City of Hapeville

Design Review Committee

July 17, 2019

PLANNER'S REPORT

AK Avasth's Proposed Design of sunroom - 3210 Oakdale Rd. Hapeville, Ga 30354

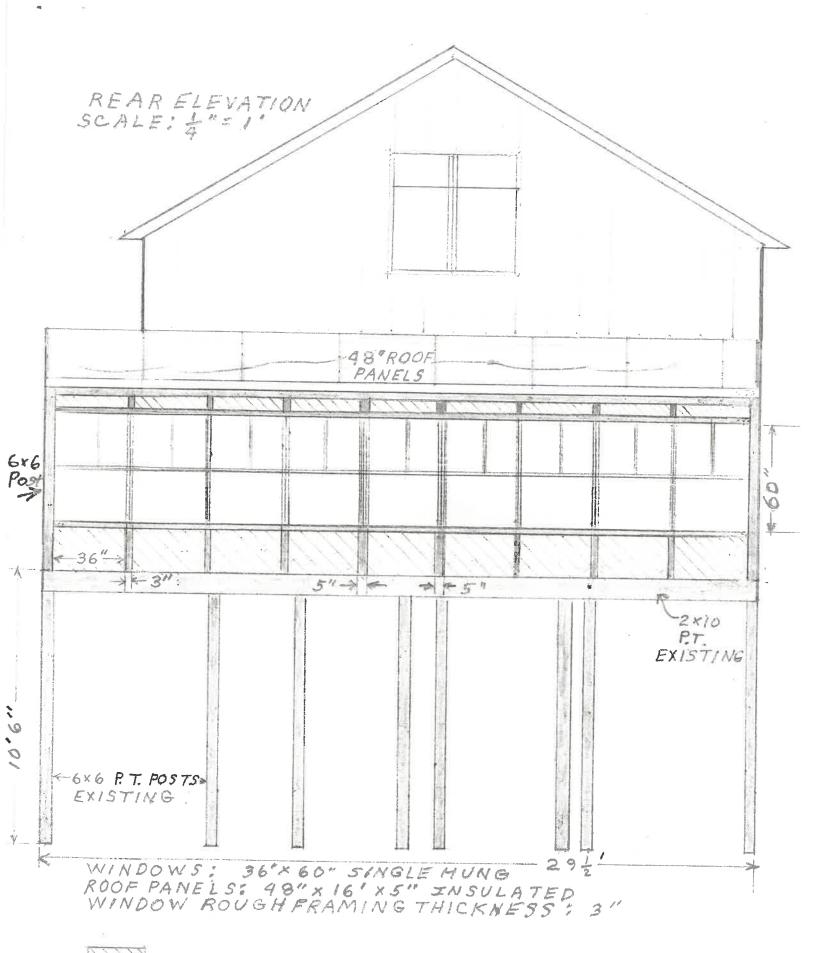
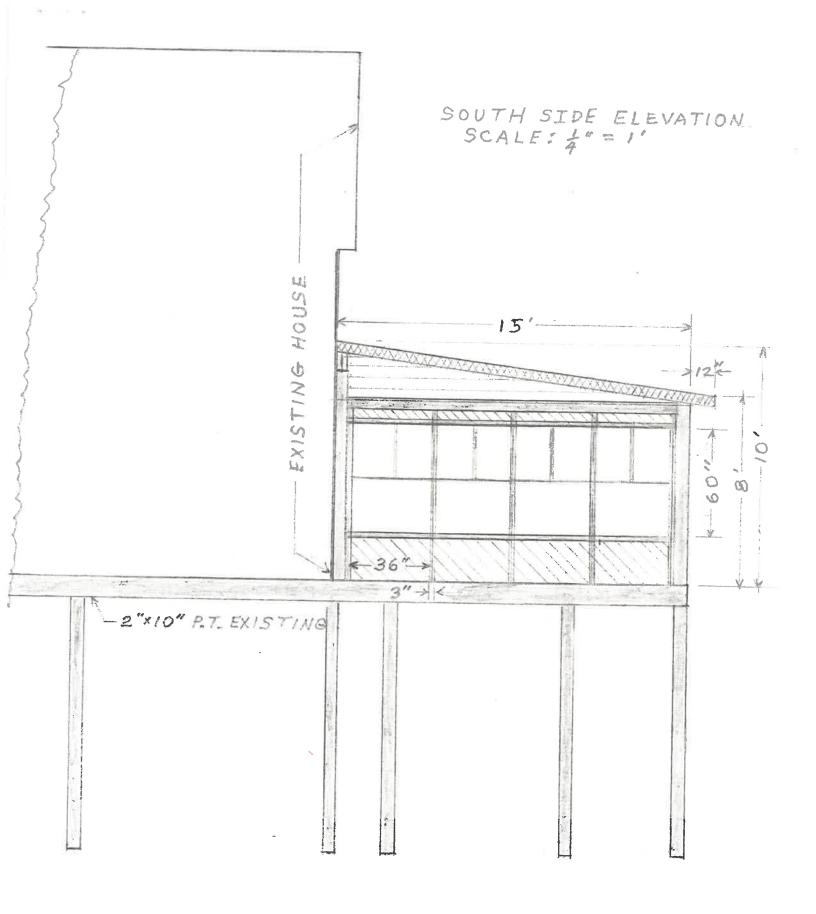
The proposed sunroom is to be constructed out of 3' wide glass panels held in place by 3", 5" and 6" posts which appear to be wooden. As such, this constitutes a glass curtain wall, which is not permitted. Further, the sloped roof made of insulated panels would be inconsistent with the roof of the existing building and lacks any gutters or downspouts and per the drawing, and the sunroom extends beyond the side of the residence.

SITE PLAN

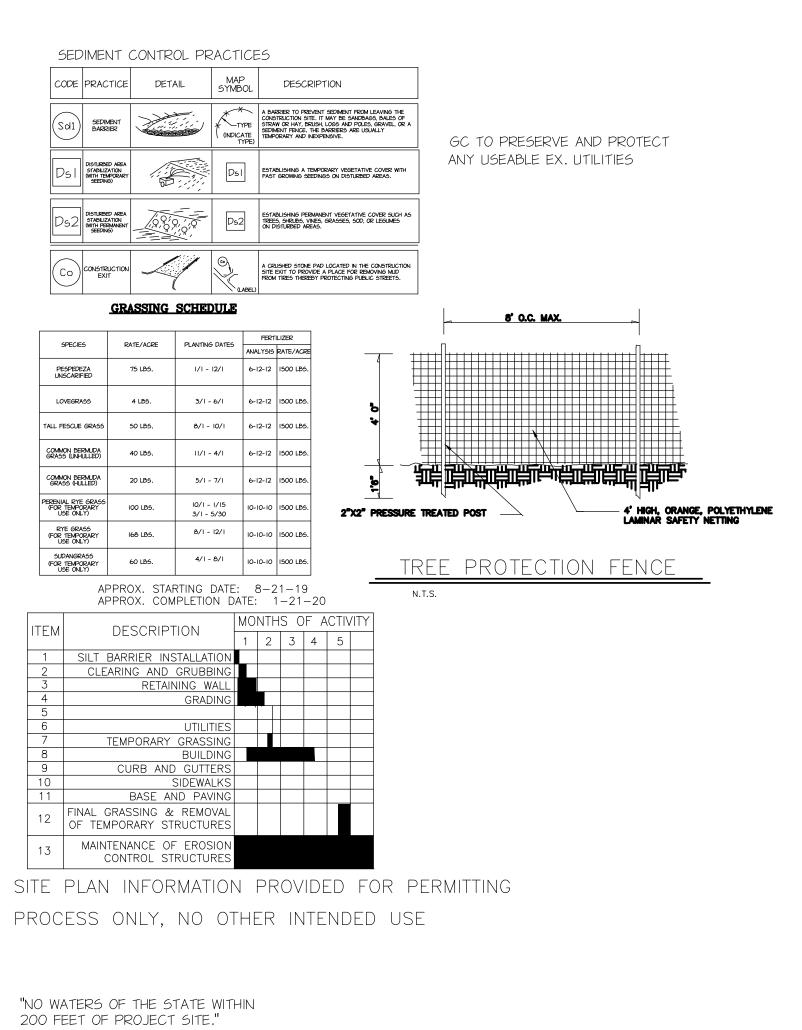
The revised site plan shows a sidewalk along Northside Drive, with no sidewalk shown along Old Jonesboro Road. The applicant states she wishes to build a partial sidewalk along Old Jonesboro Road. A partial sidewalk is not compliant.

- 2. A minimum of one tree is required every 50' in the supplemental area. The application should be revised to ensure at least one tree is located every 50' along both Northside Drive and Old Jonesboro Road frontages.
 - Existing and proposed trees will be sufficient to address placement requirements. Tree species will be reviewed by the City Arborist to address compliance with the City's Tree Ordinance.
- 3. The Applicant should clarify how the mechanical features on the west side of the dwelling will be screened.

The A/C unit has been moved to the south side of the house and now appears to be attached to the main building. The unit is included on the floor plans but not the elevations. Mechanical features are not allowed in the supplemental area. Additional information must be provided.

The plans should include a new sidewalk on each enfronting street, with a minimum 1' landscape zone and 4' clear zone. **A-7.0**

A minimum of one tree is required every 50' in the supplemental area. The application should be revised to ensure at least one tree is located every 50' along both Northside Drive and Old Jonesboro Road frontages. **A-7.0**
